From: Koepsell, Arthur
To: ["Brian Hedberg"](#)
Subject: RE: Jenny C 1 form 2A Document # 400261755, Natural Resources Group
Date: Monday, July 02, 2012 8:20:00 AM

The COGCC is reviewing the Form 2A (#400261755) for the Natural Resources Group Jenny C 1 location, located in the NWNW Sec 36 T26S R67W Huerfano County, Colorado. The COGCC requests the following changes to the information provided and acknowledgement of conditions of approval prior to passing the Oil and Gas Location Assessment (OGLA).

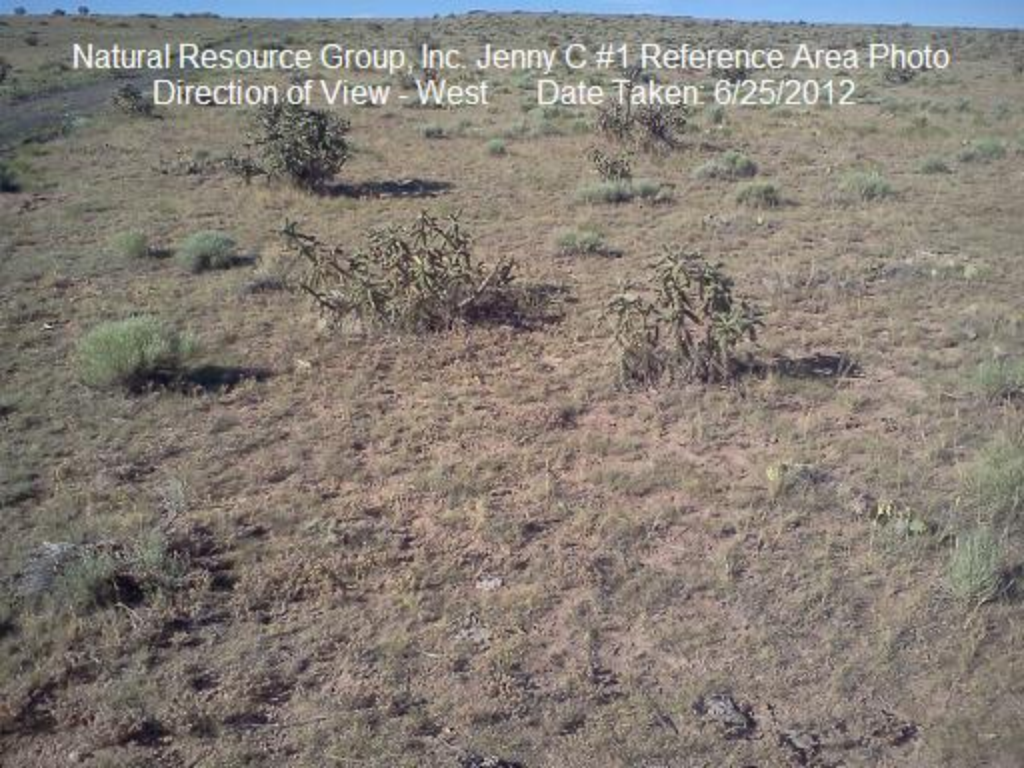
The attached photos do not meet the requirements for Reference area photos. The photos are required to show undisturbed ground, the photos you included show roads and other disturbance to the ground. Please submit photos that show undisturbed ground similar to the proposed pas location. In addition a reference area map is required per rule 303.d.3.ii.aa.

Attached to this email please see the reference area photos (north, south, east and west). The photos were taken of the area immediately adjacent to the north.
